CITY OF NORTHFIELD, MN CITY COUNCIL RESOLUTION 2021-087

APPROVING A PRELIMINARY PLAT FOR THE KRAEWOOD ADDITION

PRELIMINARY PLAT

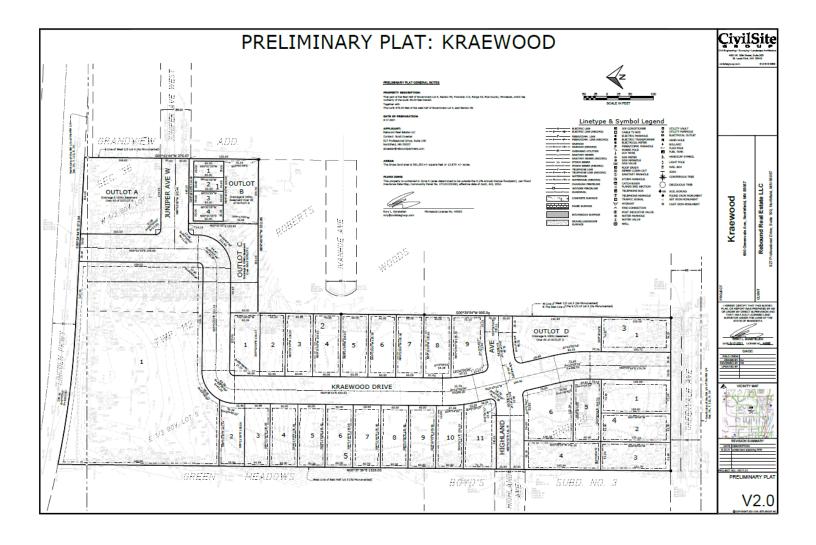
Staff Response: The preliminary plat will require a few modifications, which are identified in the recommended conditions. Staff will be working with the applicant on final engineering and design details prior to the Final Plat.

Staff Response: Development of the site will include grading, new public infrastructure and residential development and will convert the land from a former tree farm to a residential neighborhood. The City of Northfield Natural Resources Inventory identifies the perimeter of the tree farm as Woodlands and Forest in the Semi-Natural and Planted Communities. The trees on the perimeter of the site are planned to be maintained and preserved as part of the preliminary plat submittal documents. Much of Outlots A, B and C will maintain significant tree preservation. The rears of the single family homes will do the same. In addition, the developer proposes to provide native and pollinator friendly planting throughout the plat. The plat is not expected to result in substantial or irreversible environmental damage.

Staff Response: There may be an existing driveway access easement for the property owners at 600 Greenvale Ave. Staff will review the potential easement with the city attorney and the applicant. No other easements are known at this time. If there is an easement, it will follow the vacation process through the City Council.

- 4. A 6-foot sidewalk shall be constructed on the south side of Lincoln Parkway from Green Meadow Court to Linden Street North by the Applicant and shown in the Final Plat.

- 5. Highland Avenue shall be fully constructed (i.e. utilities, grading, pavement and curb installed) to the east of Kraewood Dr. to within 20 feet of the east property line as determined by the City Engineer and shown in the Final Plat.

- 6. Streets throughout the plat shall be constructed no more than 28 feet wide and shown in the Final Plat.
- 7. Right-of-way throughout the plat shall be no wider than 52 feet wide and shown in the Final Plat.

- 8. Sidewalks throughout the plat shall be no less than 6 feet wide and shown in the Final Plat.
- 9. A 20-foot access for ingress/egress for emergency vehicles shall be shown on the Final Plat and the same shall be created and installed by the Applicant that connects Ivanhoe Drive to Kraewood Drive.
- 10. The Applicant shall meet the park dedication requirements in City Code, Chapter 34, Section 5.2.6 in the form of cash payment in lieu of land dedication for parks and open space acquisition and development.
